RECORD OF DECISION AMENDMENT

Harbor at Hastings
Operable Unit Number 01: On-Site Contamination
State Superfund Project
Hastings-on-Hudson, Westchester County
Site No. 360022
March 2012

Prepared by
Division of Environmental Remediation
New York State Department of Environmental Conservation

FIGURE 3

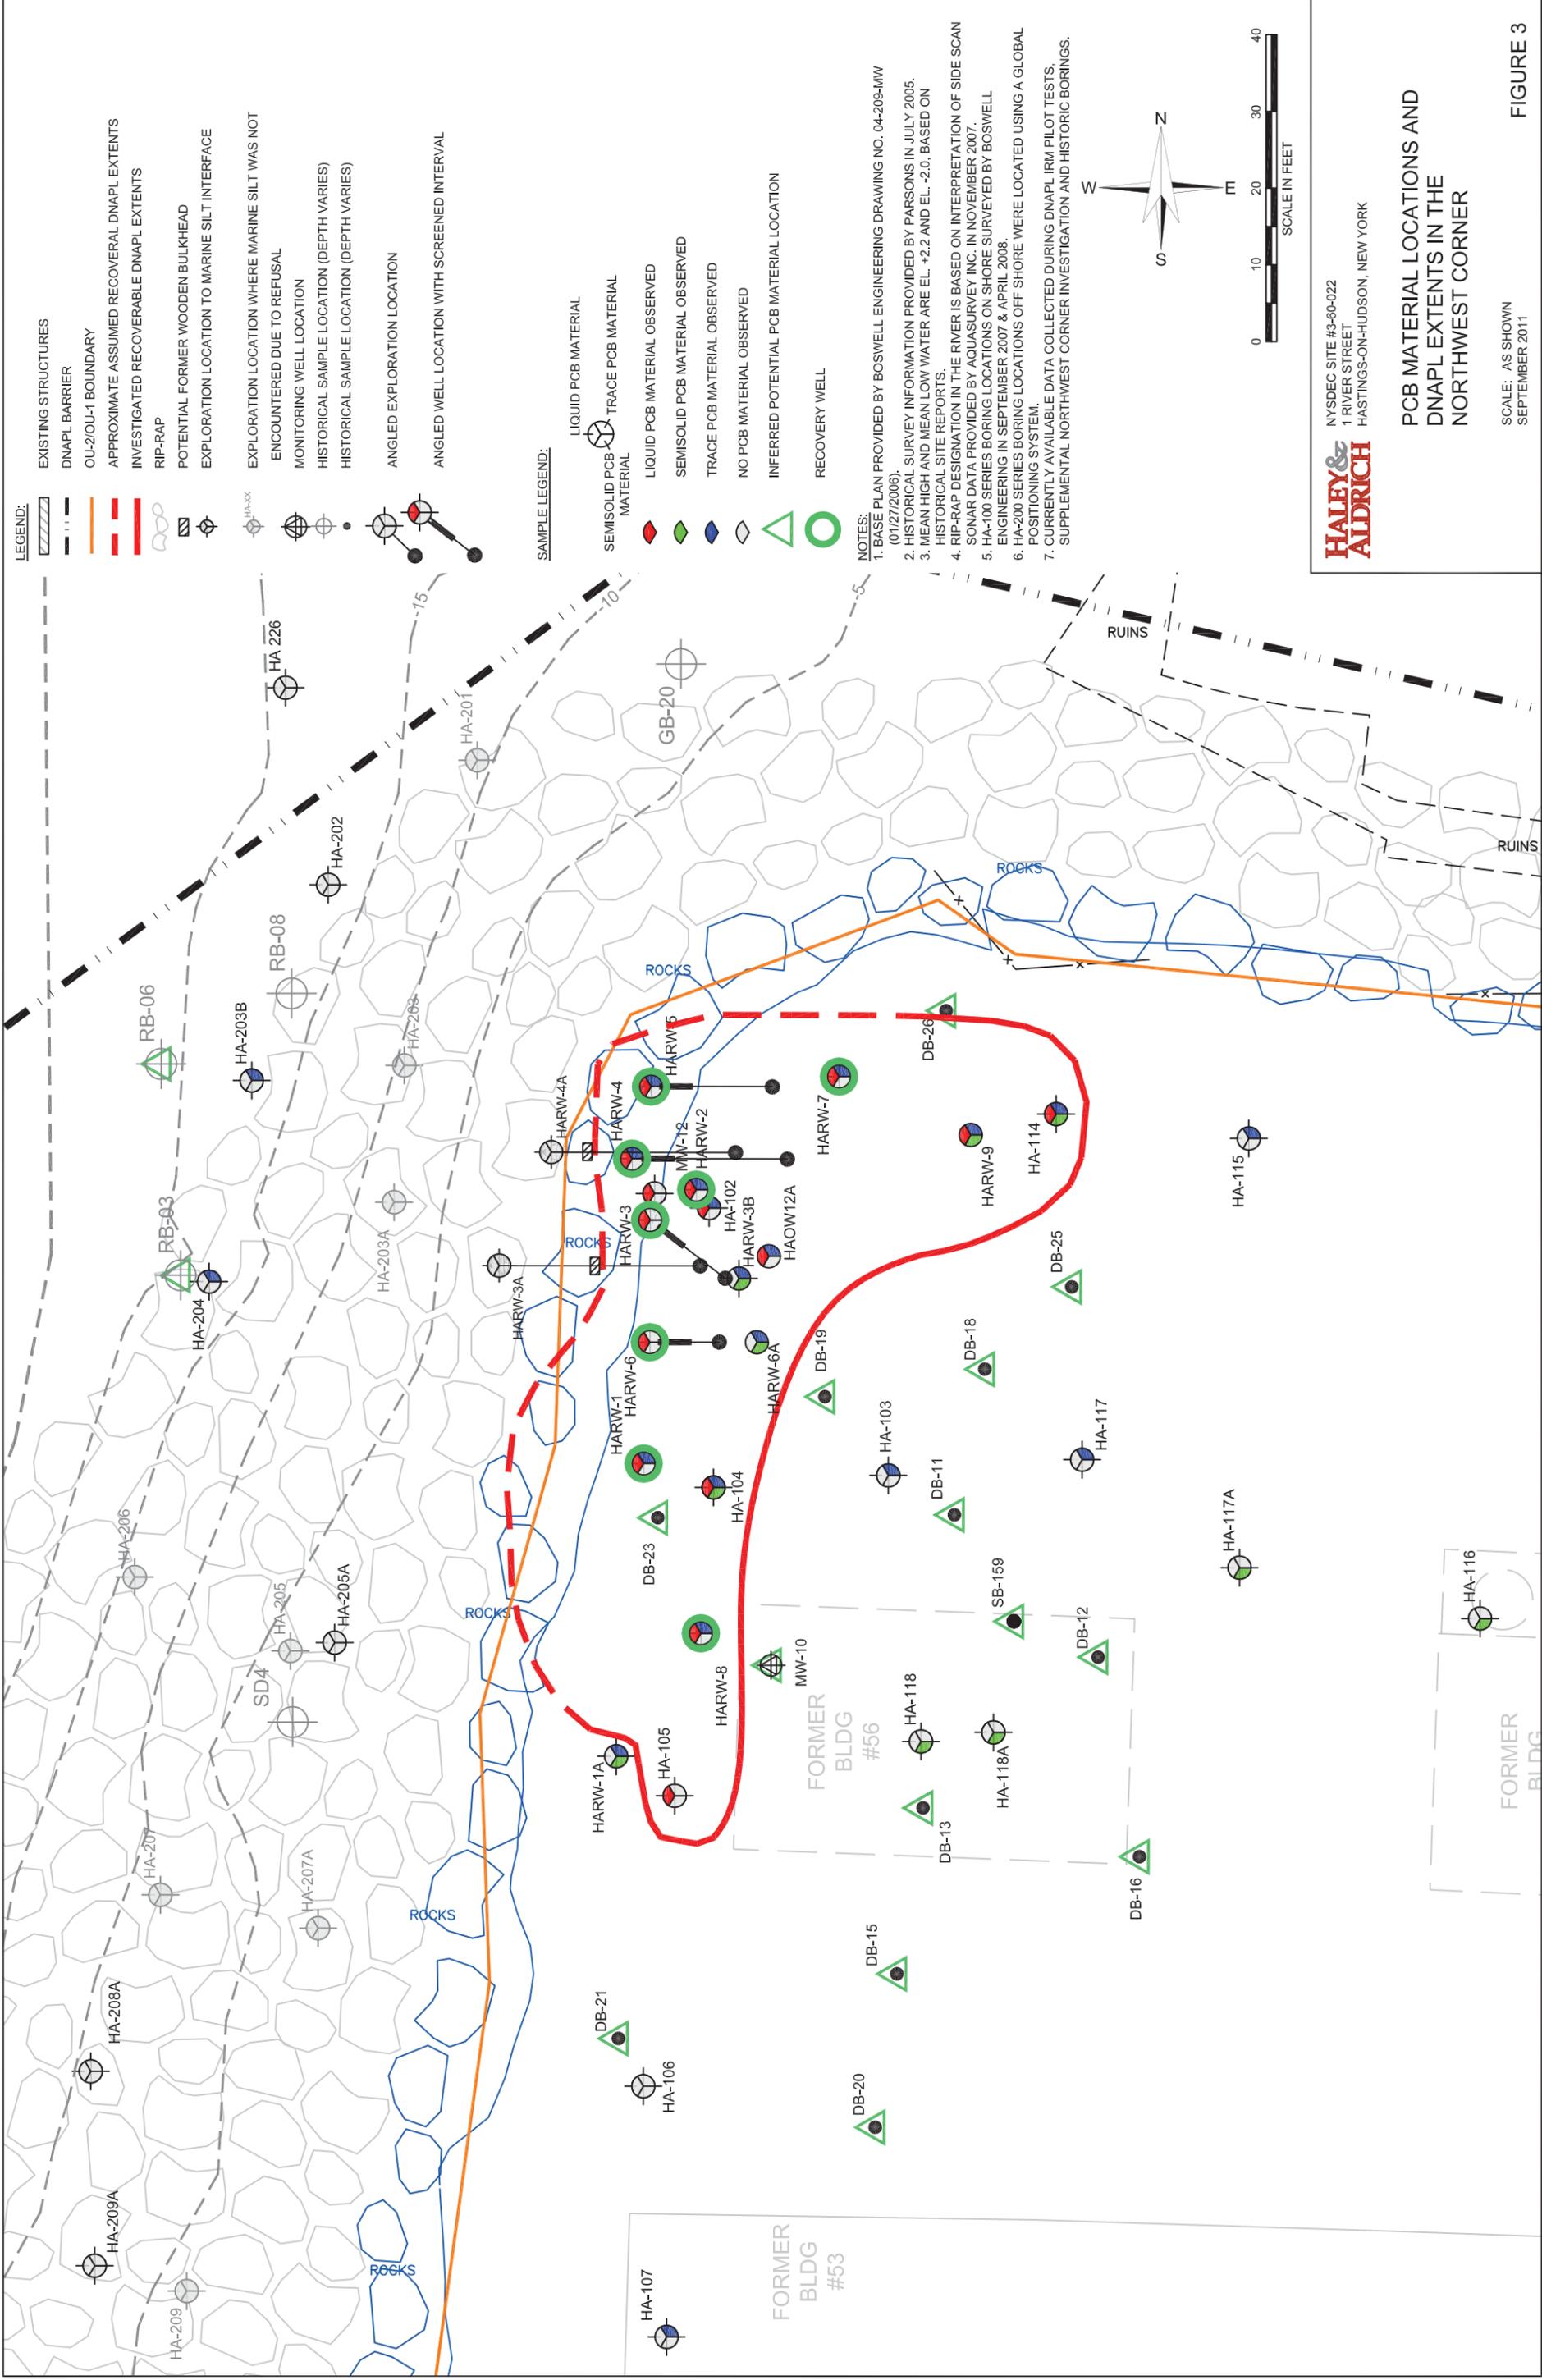
COMMENT 5: How much semi-solid PCBs are present beneath the river?

RESPONSE 5: The presence of semi-solid PCB has been identified in the areas shown on Figure 3 of the ROD. The full extent and amount of semi-solid PCBs present beneath the river has been difficult to estimate due to the difficulty in installing borings and sampling the area immediately offshore of the Northwest Corner. This area was not extensively sampled because the equipment needed to penetrate the rip rap could not access areas of shallow water under current conditions.
